AMENDMENT NO. 2 DECEMBER 2024
TO
IS 16988 : 2018 COMPRESSED NATURAL GAS CYLINDER VALVE INTEGRATED
WITH SOLENOID OPERATION (REMOTELY CONTROLLED) FOR
AUTOMOTIVE USE — SPECIFICATION

ENLARGED DETAIL AT X

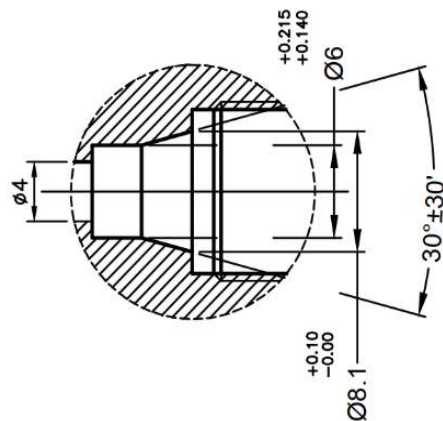
(Page 14, Outlet No. 21A) — Substitute the existing 'ENLARGED DETAIL AT X' by the following 'ENLARGED DETAIL AT X':
